REGIONAL MUNICIPALITY OF OTTAWA CARLETON
MUNICIPALITÉ RÉGIONALE D'OTTAWA CARLETON

DATE 12 November 1997

SUBJECT/OBJET **NORTEL CARLING CAMPUS EXPANSION - ADDENDUM
REPORT**

APPROVED MODIFICATIONS TO MOODIE DRIVE BETWEEN CRYSTAL BAY CENTRE ACCESS AND CORKSTOWN ROAD

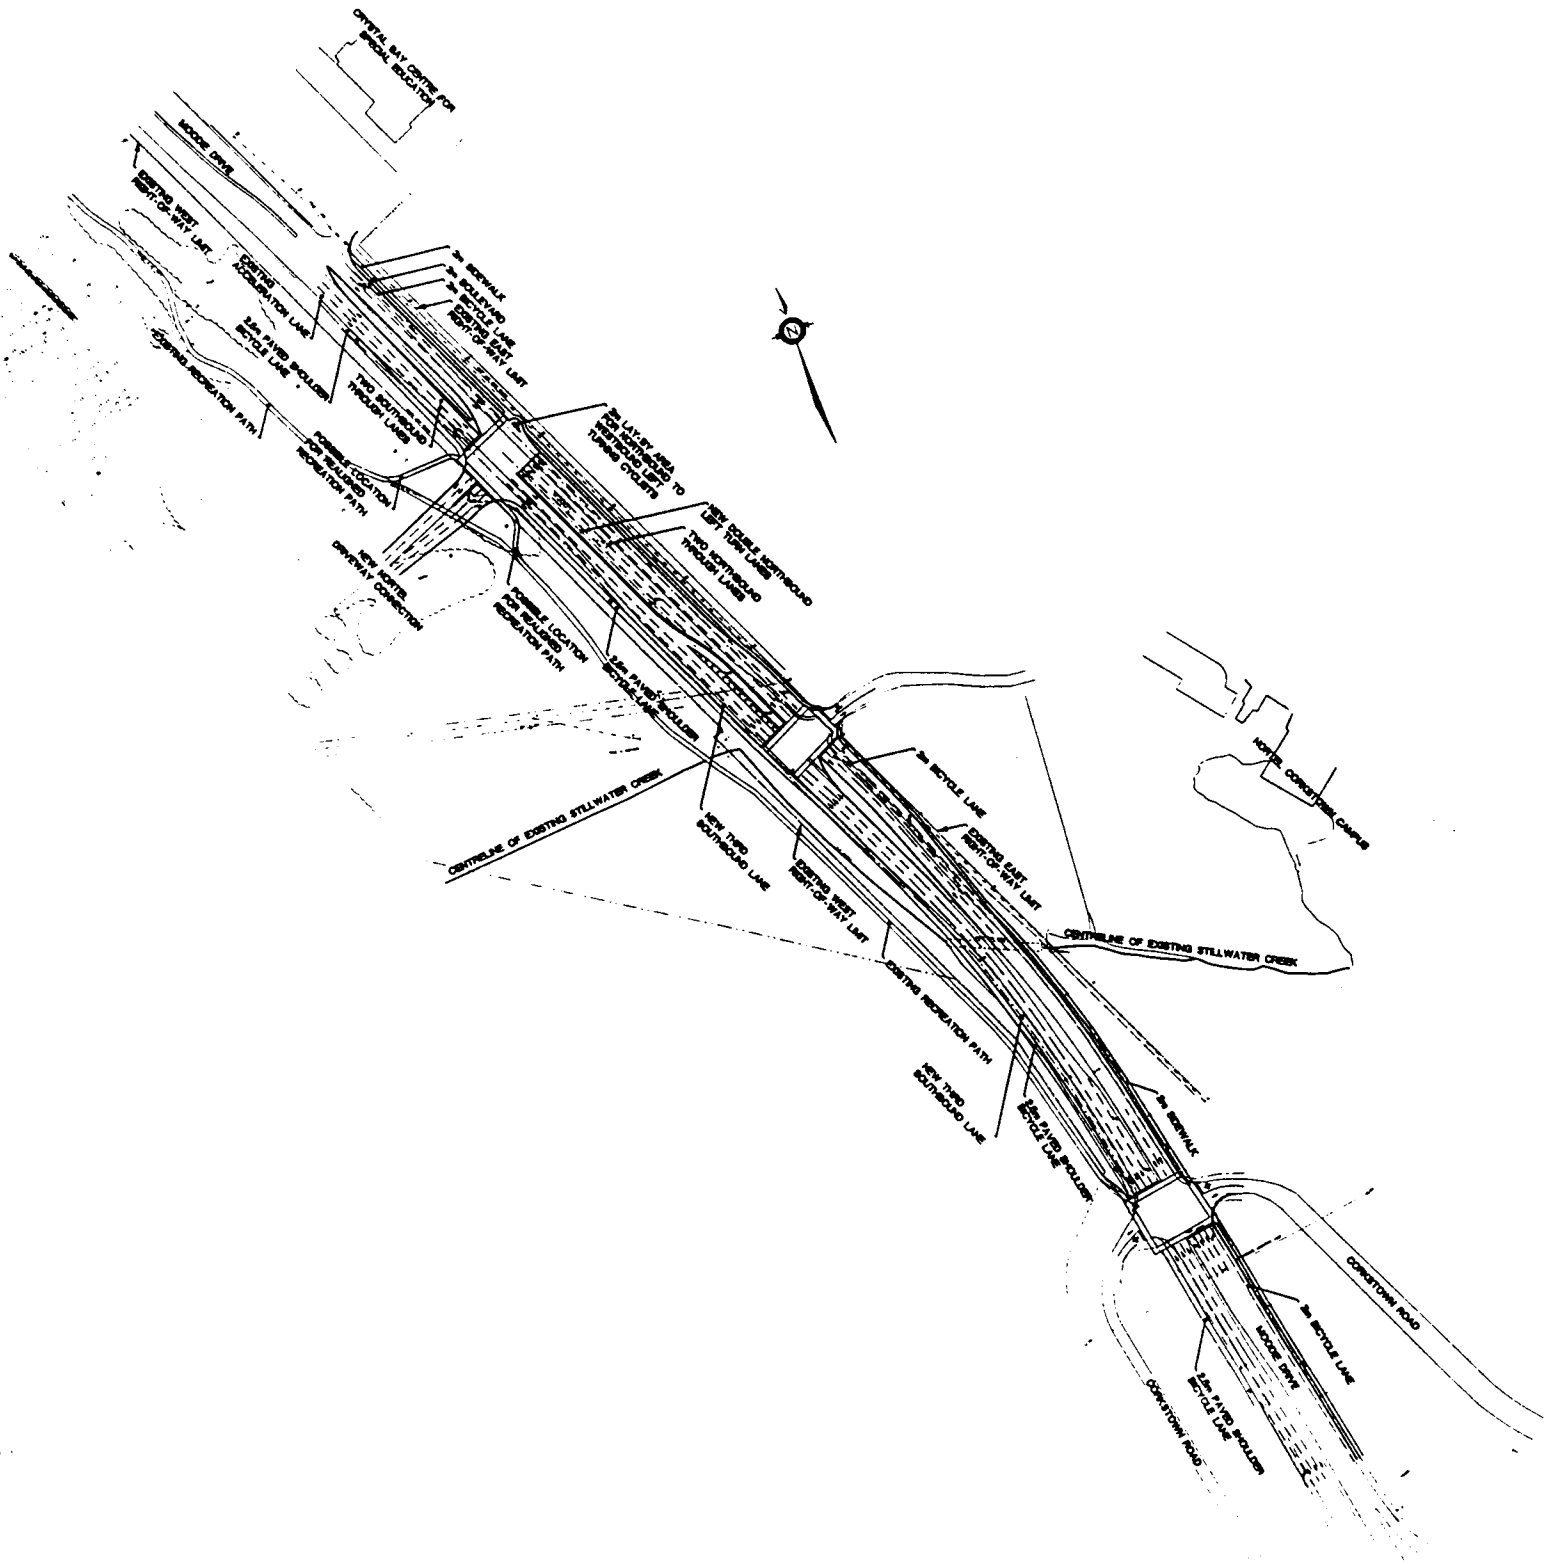
2. Moodie S at new Nortel Entrance

- * bike lane must continue through intersection as per TAC guidelines.
- * off-road path crossing at intersection should be signed "cyclist dismount"
- * off-road path should be signed to encourage cyclist to use Nortel internal east road.
